Design and Access Statement Addendum Detailed Planning Application

1.1 This addendum to the Design and Access Statement has been prepared in support of amendments made to planning application PP/17/05782 (GLA ref: 3109a) for the mixed use redevelopment of the Newcombe House Site in the Royal Borough of Kensington and Chelsea. This report should be read in conjunction with the Design and Access Statement dated September 2017.

Diagram of revised building height illustrated in blue

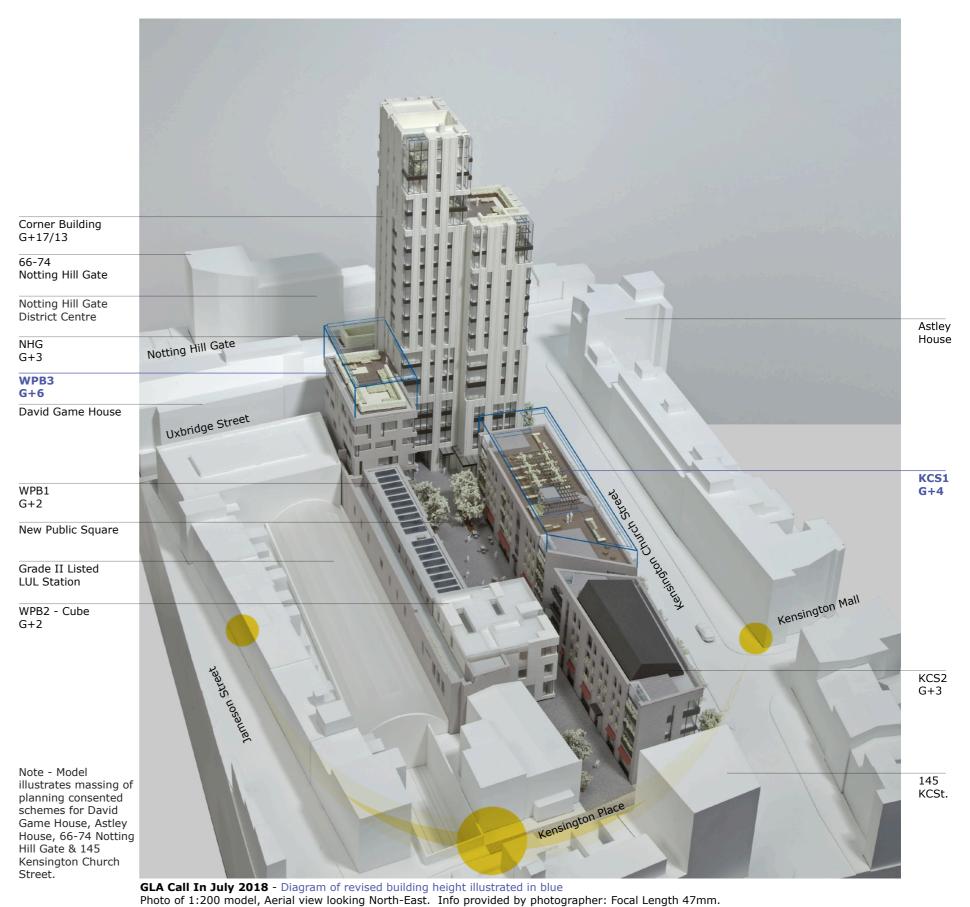
- **KCS1** massing has been increased by 1 floor, from 4 to 5 storeys. The communal private terrace (residents) has been integrated within the new floor. The proposal delivers a clearly defined roof line, appropriate for the new building's height and overall proportions. The proposed height relates positively to the NHG Building and reflects the heights of existing buildings along Kensington Church Street.
- WPB3 massing has been increased by 2 floors, from 5 to 7 storeys. The 6th floor of the Corner Building Central Form, which marks a change in the layout typology, now aligns with the top of WPB3.

No other increase in massing which impact building heights have been proposed (including the Corner Building). Small refinements to roof elements, behind and below the roof's parapet line and not exposed on the elevation, have been made to KCS2, WPB1 and WPB2 and are described further in the document.
